Generic Design Assessment – New Civil Reactor Build
Step 4 Reactor Chemistry Assessment of the Westinghouse AP1000[®] Reactor

EXECUTIVE SUMMARY

Figure 2: AP1000 Chemical and Volume Control System

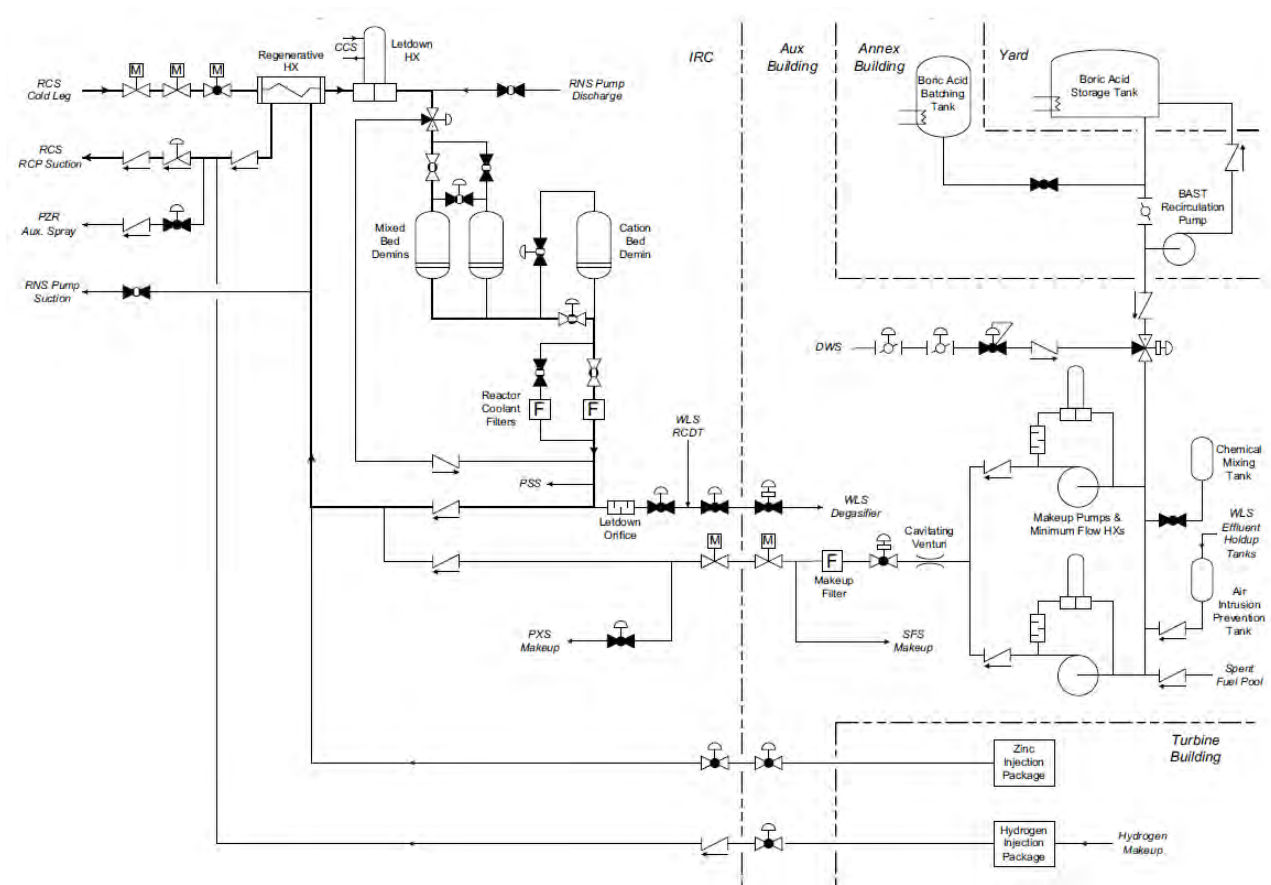
131 However, it was recognised that the overall simplification was potentially double-edged and questions were raised to assess differences from more conventional CVS designs including:

- How the purification ion-exchange units perform at full system pressure.
- Whether hydrogen addition would be effective and controllable.
- If the offline degasifier made up for the lack of a Volume Control Tank (VCT).
- The impact of the in-containment location (for example for maintenance, filter change etc.).

Figure 4: Typical AP1000 Boron-Lithium Coordination and pH_T Profile

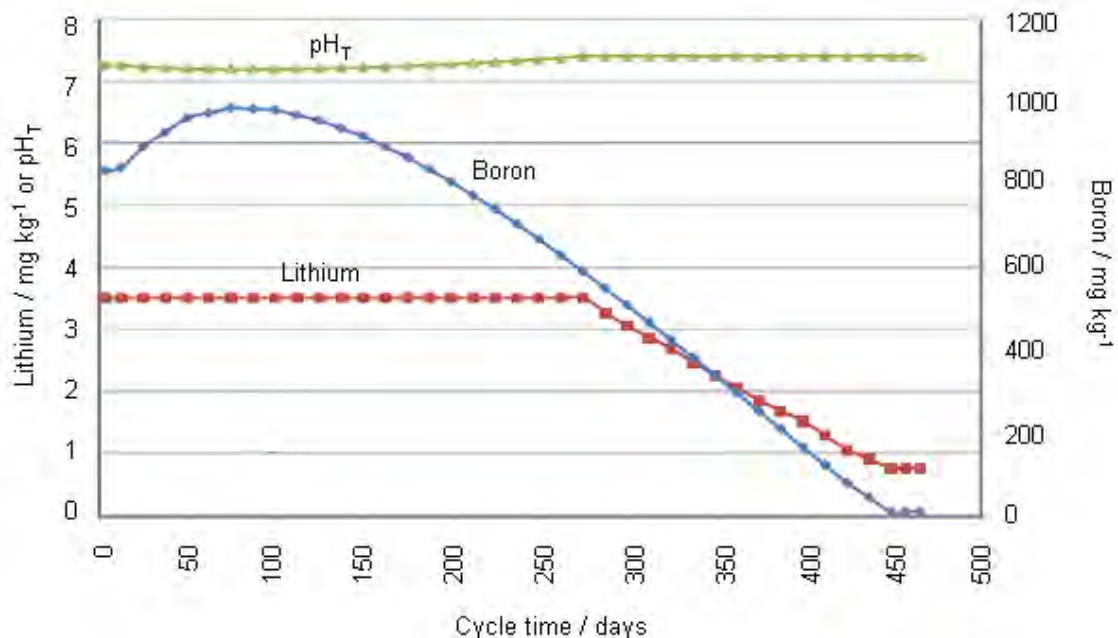
290 The description provided in the response to RO-AP1000-57.A2 (Ref. 165) shows that the pH_T in AP1000 is likely to follow an "elevated chemistry" pH programme, whereby the lithium is held as close to the [REDACTED] mg kg⁻¹ limit as possible for most of the cycle, until the boron concentration decreases to such a level that the lithium and boron can be coordinated to maintain a constant pH_T. This results in a pH_T that varies throughout the cycle, gradually increasing as the burn-up increases before reaching the plateau as the coordination stage begins. Such chemistry is shown below, and is common in many US PWRs. This type of chemistry regime has been shown to reduce radiation levels in plants, compared to coordination at constant, lower pH_T. The RO-AP1000-57.A2 response (Ref. 165) indicates that the pH_T will start at around 7.0 and rise to around 7.3 towards the end of the cycle, but this is dependant upon many factors including the detailed core design which are not known at present.

- 291 Based on these parameters Westinghouse claims that “*worst case*” contamination levels will be around 1 GBq m² in the SG (Ref. 135). At face value this can be considered as excellent performance especially given the higher duty of the generic core and a number of the design features of AP1000. In producing such an optimistic prediction there is a risk that this may not motivate a Licensee to implement the key controls needed to ensure crud production, out of core radiation and radwaste production will be ALARP.

Figure 14: AP1000 Reactor Pressure Vessel Insulation

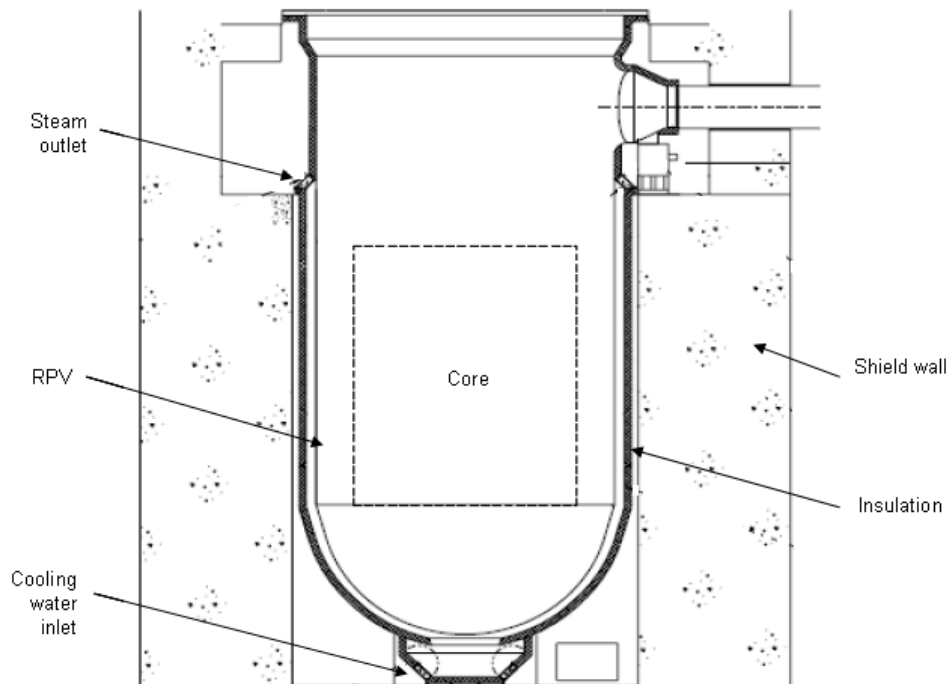
- 1119 If the strategy is to flood the pit, then borated water should be used to avoid a risk of re-criticality. The borated water would be provided from the IRWST in AP1000.
- 1120 The reliability, design and efficiency of the systems used to remove heat from the RPV in AP1000 is the single aspect of the design for IVR which dominates all others, including the chemistry. There is a critical heat flux (of $1,800 \text{ kW m}^{-2}$ at the RPV waistline) above which vessel failure should be expected. Below this value, IVR is successful. Values of the critical heat flux at different points on the AP600/1000 vessel wall were determined in the ULPU experiments (Ref. 209). AP1000 has a higher decay power than AP600, so the circulation of the water in the pit was enhanced by permitting circulation over the skin of the pressure vessel inside the heat shield (Ref. 203).

- 1121 Westinghouse has considered factors that might decrease the efficiency of external cooling. The effects of pure water and water with tri-sodium phosphate (TSoP) and with boric acid were compared in the ULPU tests. External cooling was least effective with pure water and most effective with TSoP dissolved. The effects of boric acid and TSoP tended to cancel but the mixture was still better than pure water (Refs 204 and 209). Two-phase flow in the cooling channel would flush any precipitated boron or TSoP out from under the heat shield.
